**LOS ANGELES UNION STATION
FORECOURT AND ESPLANADE IMPROVEMENTS PROJECT**

ADDENDUM NO. 2 TO THE ENVIRONMENTAL IMPACT REPORT

SEPTEMBER 9, 2020

Figure 3 – Modified Project Plan

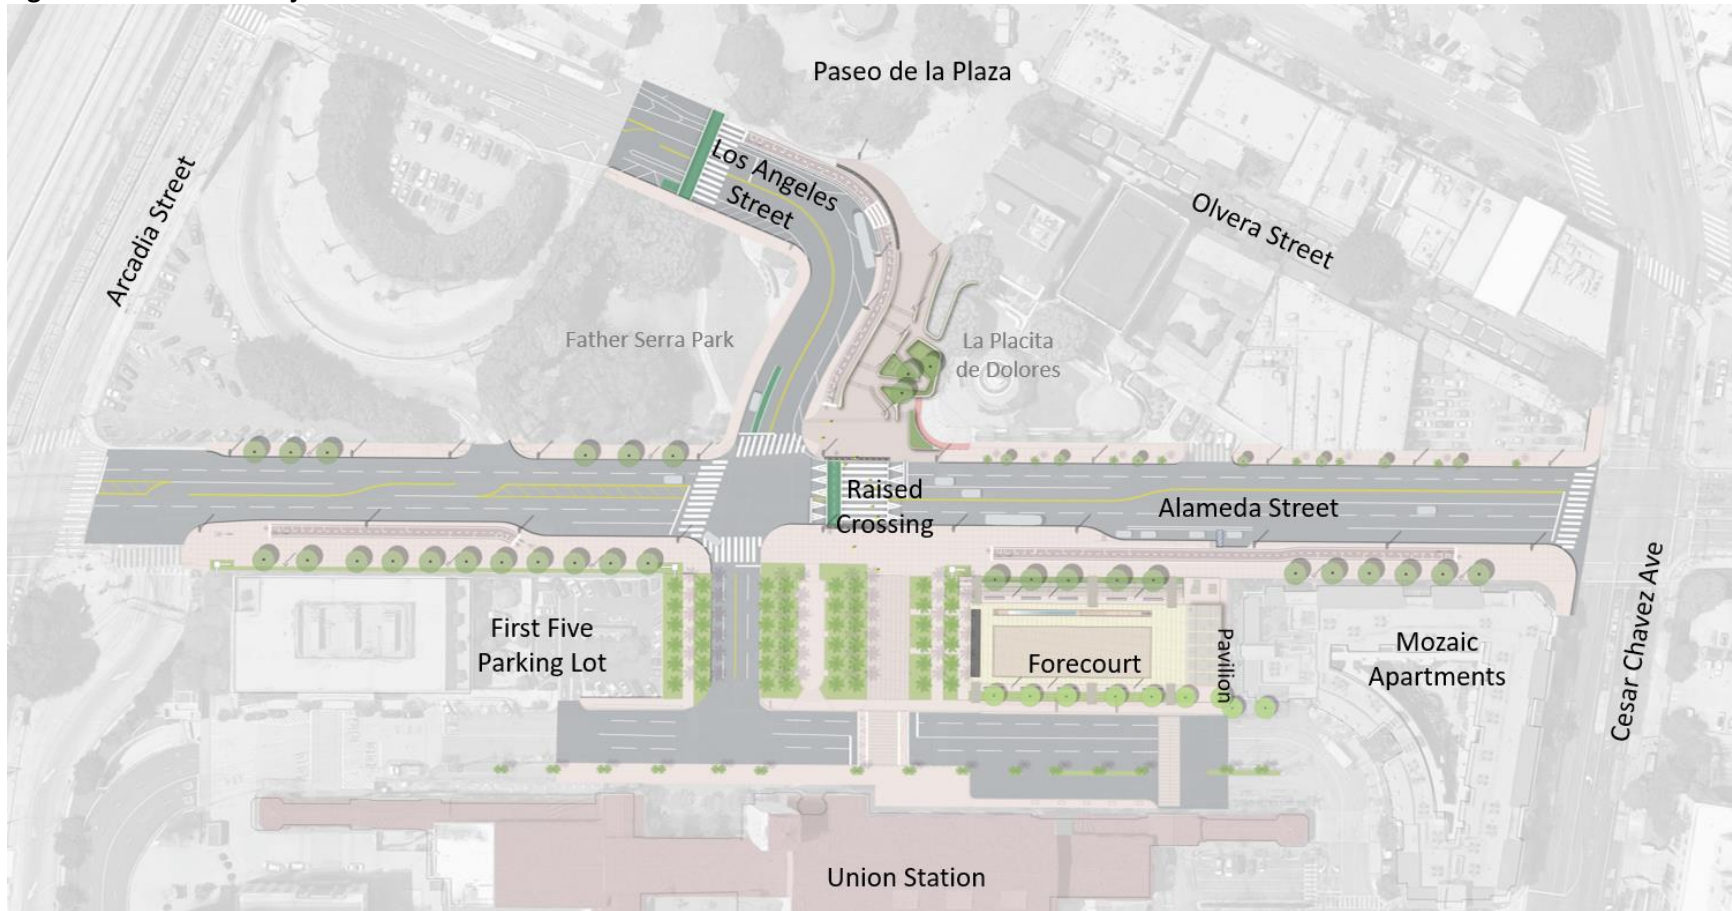
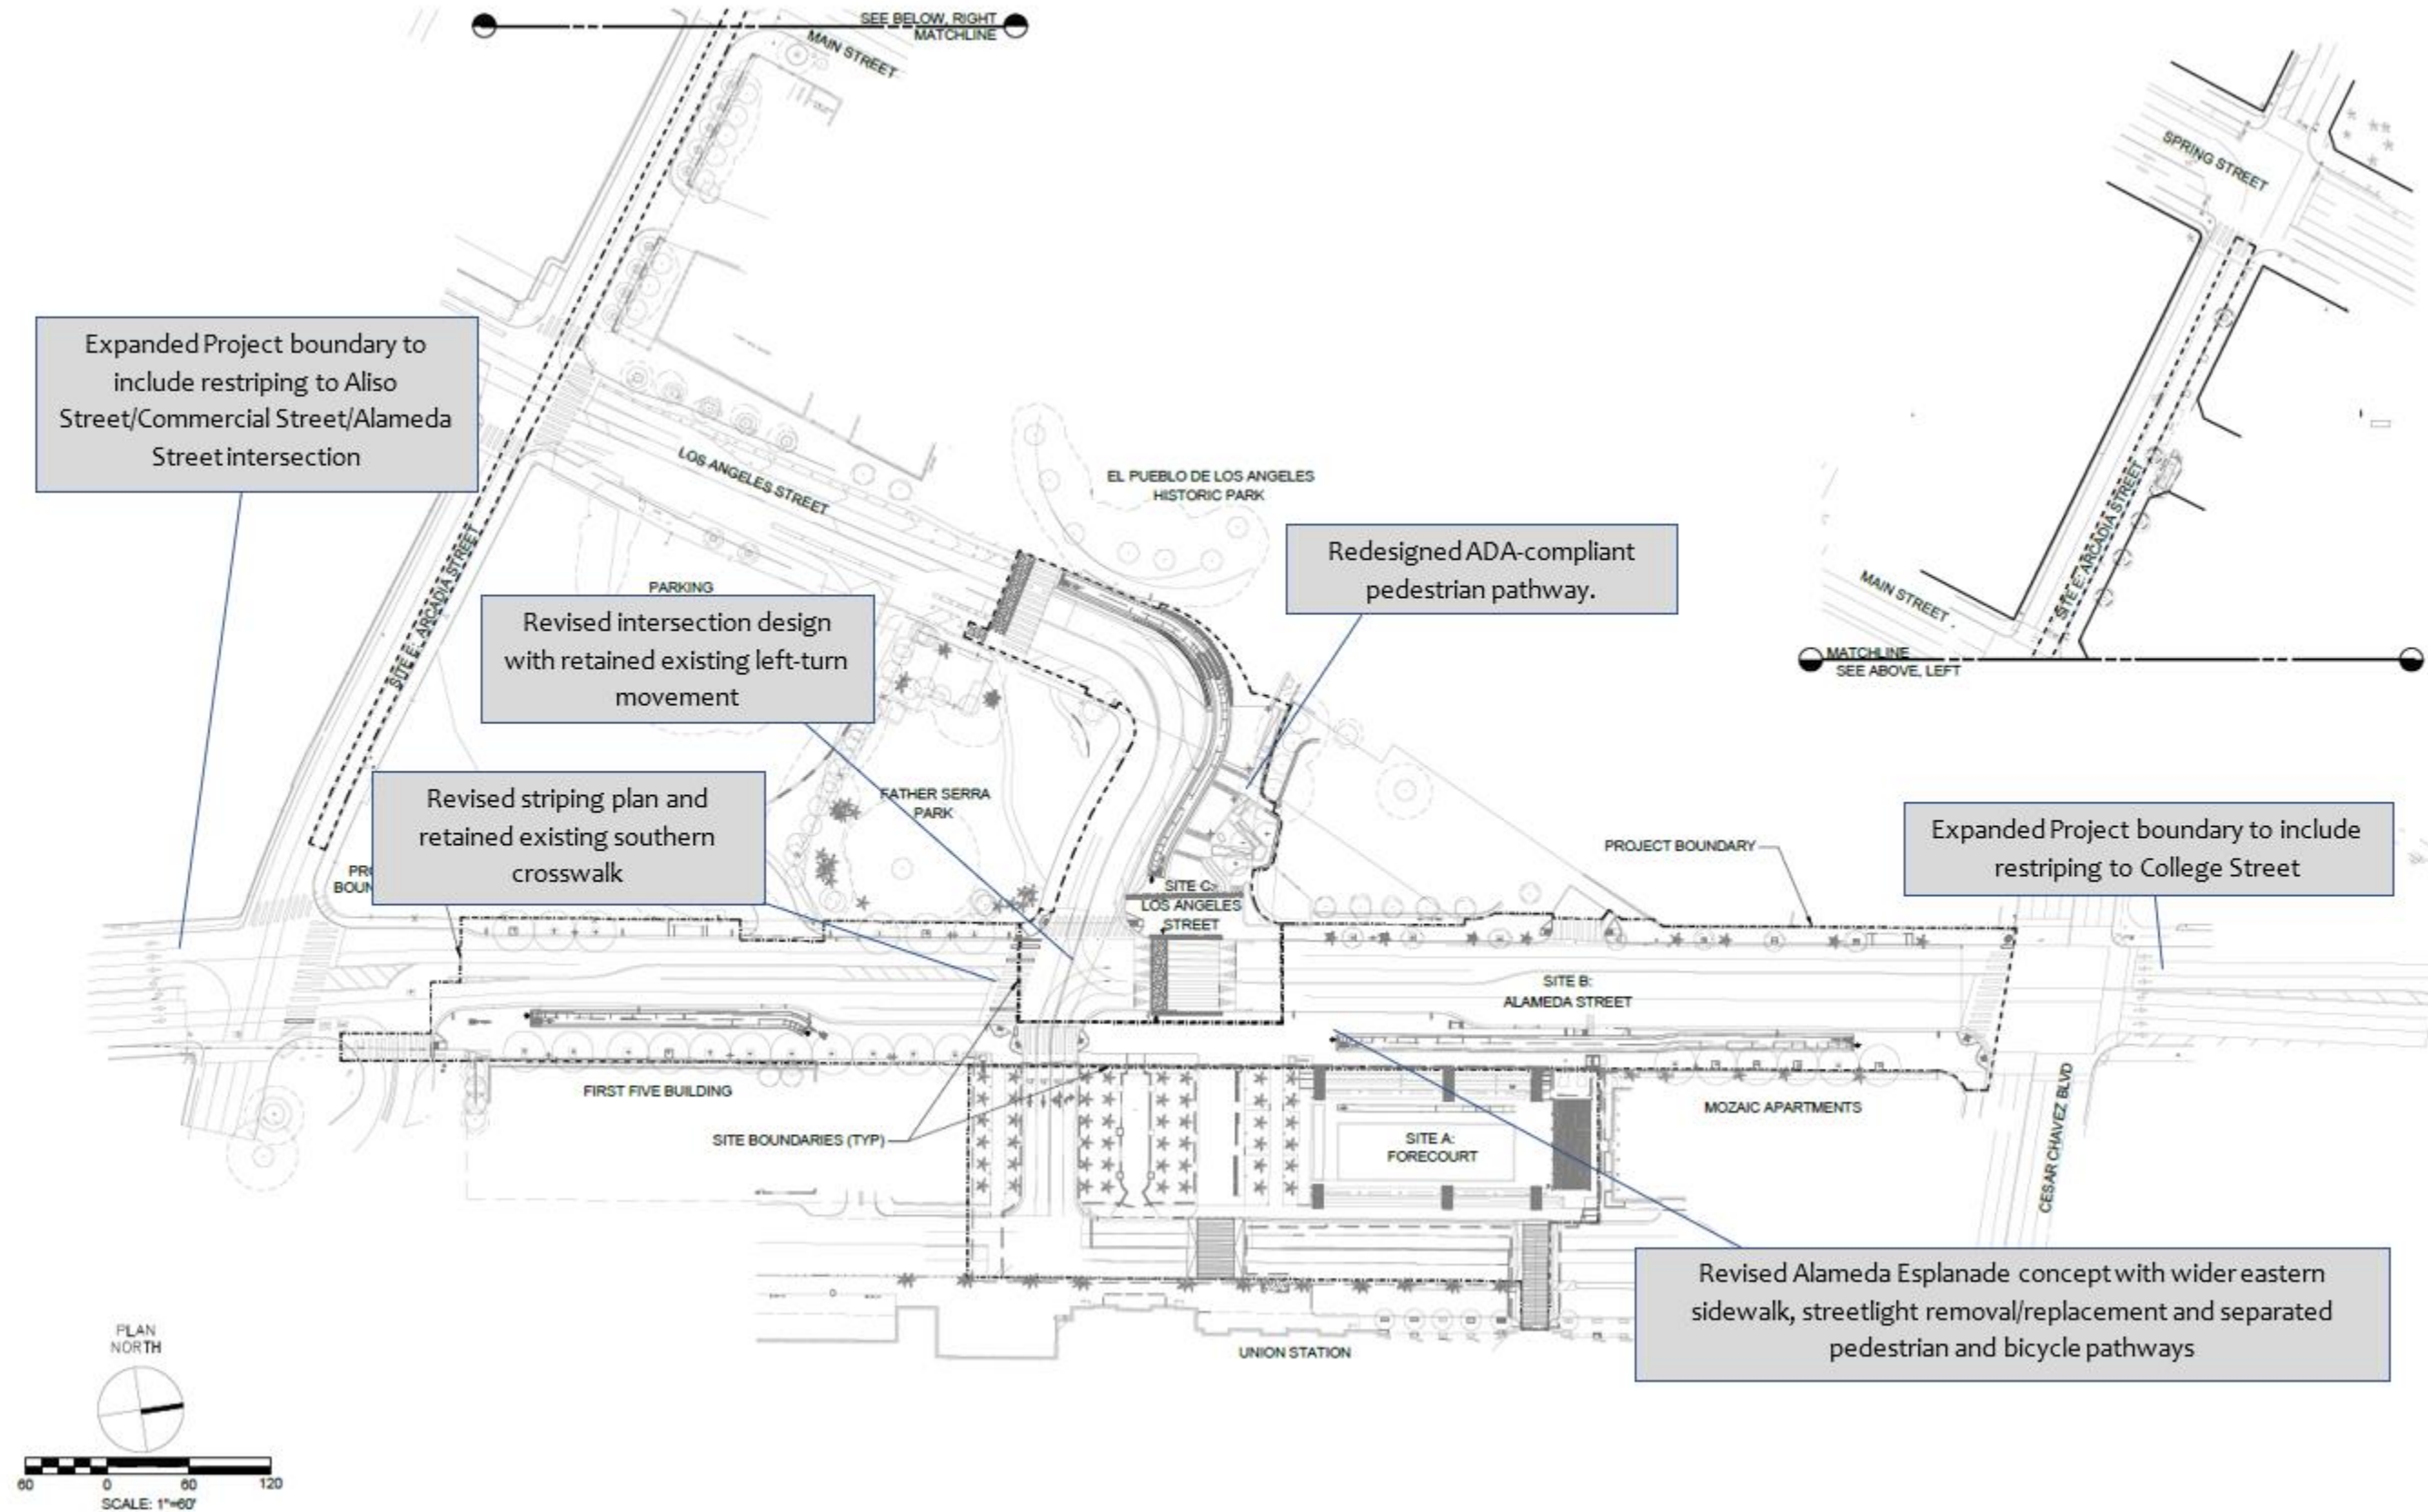
1. Alameda Esplanade Revisions,
2. Intersection and Roadway Modifications,
3. Removal and Replacement of Streetlights,
4. Removal and Replacement of Additional Utilities, and
5. Redesigned ADA-Compliant Los Angeles Street Pathway (**Figure 3**, Modified Site Plan, and **Figure 4**, Proposed Modifications)

The Approved Project Alameda Esplanade concept in the Certified EIR included the removal of two vehicular travel lanes on Alameda Street, widening of the eastern and western sidewalks, and a new shared pedestrian and bicyclist multi-use path on the eastern sidewalk. As part of the Modified Project under this addendum, two vehicular travel lanes on Alameda Street would still be removed, but all the gained area within the right-of-way would be shifted to the eastern sidewalk to accommodate a separated bicycle and pedestrian path with mixing zones¹⁰ on the eastern sidewalk. Mixing zones will be adequately designed to provide users with advanced notice of the end of the separated paths of travel and the start of a shared, mixed area for pedestrians and bicyclists.

The western sidewalks will be replaced but will be maintained at the same width. Additionally, minor modifications to the sidewalk and pavement leading up to the El Pueblo building face along the west side of Alameda Street would be required under the Modified Project. At the location, the existing pavement slope would be lowered to maintain proper stormwater flow and ADA slope recommendations resulting in a minor expansion (approximately 235 square feet) of the project limits. In addition, the current design depicts a single row of trees along the length of the proposed Alameda Esplanade, while the Approved Project proposed a double row of trees totaling 54 trees within the Esplanade. Though the design has been revised since the Approved Project to address City of Los Angeles concerns related to stormdrain root invasion, Metro is maintaining the original double tree row envelope as part of the Project to provide flexibility. The changes have been advanced because of direction from the City of Los Angeles.

Per the direction of the Los Angeles Department of Transportation (LADOT), the existing crosswalk on the south leg of the intersection of Alameda Street and Los Angeles Street, which connects Father Serra Park and Union Station, will be retained at its current location as part of the Project. The Approved Project proposed to remove it to consolidate the pedestrian and bicyclist crossing at the northern portion of the intersection adjacent to the new raised crossing. It is also noted that the Approved Project allowed for a raised crossing measuring 50 feet in width tabletop and eight inches in height representing a maximum envelope for the Approved Project. While the current design reflects a crosswalk with reduced dimensions to meet City of Los Angeles street design requirements, the Project is maintaining the original design envelope to provide flexibility.

The Approved Project proposed to remove the existing eastbound Los Angeles Street left-turn lane to northbound Alameda Street in order to eliminate a movement that would conflict with the raised crosswalk and was found to generate more traffic impacts. However, per direction from LADOT, out of concern over safety impacts associated with potential driver non-compliance with the left-turn restriction, the left-turn will be retained as part of the Modified Project. The signal phasing for the intersection of Los Angeles Street and Alameda Street will be revised to include this movement. In addition, LADOT has required that the design maintain the existing northbound Alameda Street through/right-turn movement along the curbside lane rather than converting the lane to a right-turn-only lane under the Approved Project.

As part of this Addendum #2, several roadway Project elements will be added to the design beyond the northern and southern Project boundaries along Alameda Street based on direction from LADOT. In order to eliminate the potential for a trap-left turn lane for the southbound approach of Alameda Street at Cesar E. Chavez Avenue, LADOT directed Metro to revise the striping plan to provide a more gradual transition resulting in further reduction in roadway capacity compared to the Approved Project. This Addendum #2 includes the removal of a southbound peak period travel lane from Alpine Street to Cesar E. Chavez Avenue, whereas the Approved Project did not include this peak period lane reduction.
